ADDENDA NO. 01

RFB 54-1617 - Roofing at Millikan and Wilson High Schools

Issued: June 12, 2017

Millikan High School 200 & 400 (2 Sections)

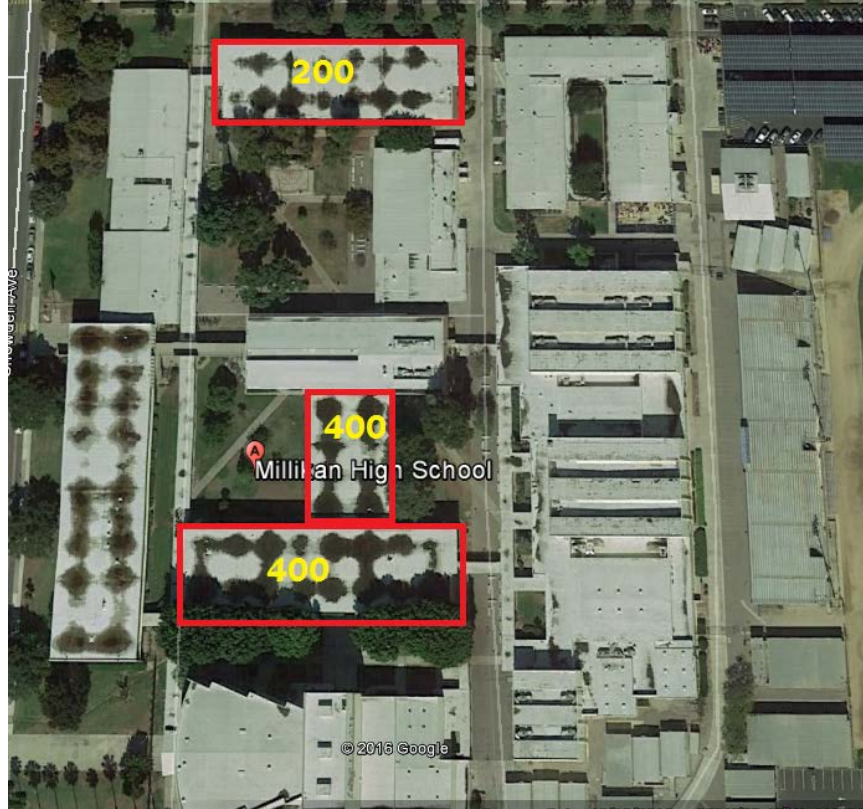
Item No. 3:

Page 75, 1.1., B (Technical Specifications):

Replace with the map below:
